Access Compliance Report Public Rights-of-Way (Curb Ramps)

Intersection ID: 15725Main Street: CLANTON_RDCross Street: S_TRYON_STLocation: NWADA ID: 9471823B2CC9Ramp Type: PerpInitial Pass/Fail: Fail Overall Compliance: No Severity Score: 37.5

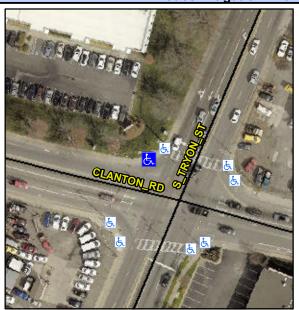
Field Measurements/Component Compilance							
Compl	iance Description	Data	Comp	liance Description	Data		
N/A	Ramp Length (in)	59.0	No	Ramp Slope (%)	8.6		
Yes	Ramp Width (in)	48.0	No	Ramp XSlope (%)	7.1		
N/A	Flare Type LT	N/A	N/A	Flare Type RT	N/A		
N/A	Flare Slope LT (%)	N/A	N/A	Flare Slope RT (%)	N/A		
N/A	Flare Traversable LT?	N/A	N/A	Flare Traversable RT?	N/A		
N/A	Landing Length (in)	N/A	N/A	DWS Provided?	N/A		
N/A	Landing Width (in)	N/A	N/A	DWS Contrast?	N/A		
N/A	Landing Slope (%)	N/A	N/A	DWS Length (in)	N/A		
N/A	Landing X Slope (%)	N/A	N/A	DWS Full Width?	N/A		
N/A	Landing Curb? (Y/N)	N/A	N/A	DWS Offset (in)	N/A		
N/A	Shared Landing?	N/A					
N/A	Gutter Ponding?	N/A	N/A	Gutter Slope (%)	N/A		
N/A	Gutter Lip Ht (in)	N/A	N/A	Gutter X Slope (%)	N/A		
N/A	Painted X Walk1?	Yes	N/A	Painted X Walk2?	N/A		
	X Walk 1 Direction	To SW		X Walk 2 Direction	N/A		
N/A	X Walk 1 Width (in)	117.0	N/A	X Walk 2 Width (in)	N/A

X Walk 1 Slope (%)	7.5		X Walk 2 Slope (%)	N/A		
	X Walk 1 X Slope (%)	3.0		X Walk 2 X Slope (%)	N/A		
N/A	Ramp inside XWalk1?	Yes	N/A	Ramp inside XWalk2?	N/A		
	Road Slope (%)	N/A	N/A	Clear Space?	N/A		
	Road X Slope (%)	N/A	N/A	Clear Space to XWalk (in)	N/A		
N/A	Any Obstructions?	N/A	N/A	Storm Grate/Utility Hazard?	N/A		
	Obstruction Type			Storm Grate/Utility Type			
		N/A			N/A		
			Yes	Surface Condition? (G/P)	Good

Possible Solutions:	Com
Remove & Replace Entire Ramp.	N/A
	Yes
	N/A
	N/A
	N/A
	N/A
Surveyor Notes:	N/A
N/A	N/A
	N/A
	N/A
	N/A
PROW/ADA:	N/A
Not Found, R304.2.2, R304.5.3	N/A
	N/A
	N/A
	N/A
